RE: **704 Lake Avenue**

TITLE: HRPB Project Number 21-00100284: Consideration of a Certificate of Appropriateness (COA) for window additions and replacement on the second story of a building located at 704 Lake Avenue; PCN# 38-43-44-21-15-508-0091. The subject building is located within the Downtown (DT) zoning district with a future land use designation of Downtown Mixed Use (DMU). It is also located within the City's Community Redevelopment Agency (CRA) overlay district and is a contributing resource within the Old Town Historic District.

Exhibit B: Alternate Window Configuration – Front (South) Facade

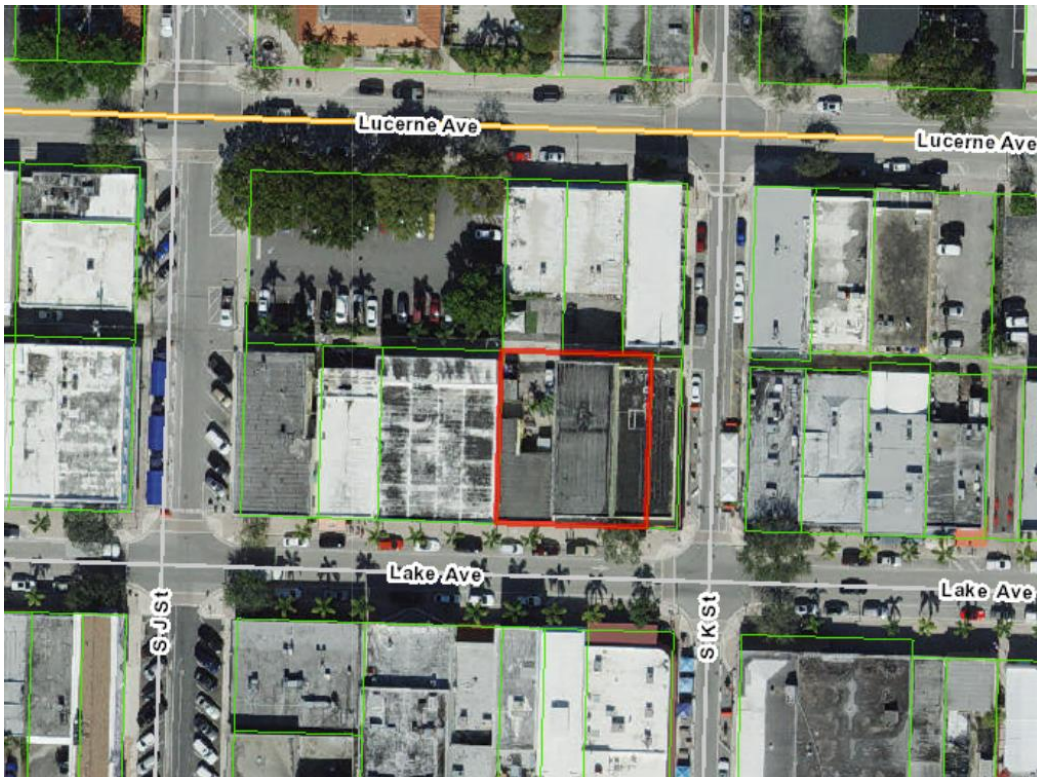
On the front (south) façade, the applicant is requesting the approval of two new fixed windows in the configuration depicted in Exhibit A below. An alternate configuration (Exhibit B) was also provided at staff's request.

Staff Analysis: The proposed window additions on the front façade do not successfully complement the existing windows on the bottom floor of the building. Staff is recommending the more vertical three-part window configuration in Exhibit B that would more successfully complement the existing window configuration on the ground floor. The proposed windows on the side and rear façades are not anticipated to have a negative effect on the structure.

Staff Analysis: The applicant’s preferred window configuration on the front façade does not successfully complement the existing architectural style of the structure. The applicant’s alternate configuration should be considered in lieu of the applicant’s preferred option. The proposed windows on the side and rear facades are not anticipated to negatively impact the historic significance of building. However, the Board may wish to discuss the window types utilized on the side facades.

Staff recommends windows depicted in Exhibit B with the removal of the stucco texture on the concrete between each set of windows.

- 1) On the front façade of the building, the window configuration in Exhibit B shall be modified to have smooth stucco finish between the windows.
- 2) Windows shall be recessed a minimum of two inches (2”) in the wall, and shall not be installed flush with the exterior wall.
- 3) The windows shall utilize glazing that is clear, non-reflective, and without tint. Low-E (low emissivity) is allowed, but the glass shall have a minimum 60% visible light transmittance (VLT) measured from the center of glazing. Glass tints or any other glass treatments shall not be combined with the Low-E coating to further diminish the VLT of the glass.
- 4) Replacement stucco texture shall be smooth.
